**Car Stereo
Service Bulletin**

Model: CDX-A10

No. 103

Subject: Missing Part Number

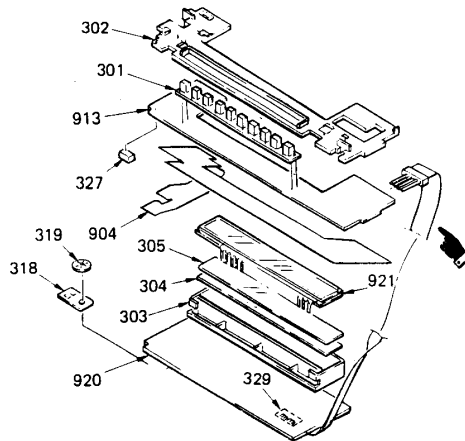
The part number for the flex connector, which connects switch PCB (Ref 913) and LCD PCB (Ref 920), is not listed in the manual.

Solution: The part number is 1-620-083-11.
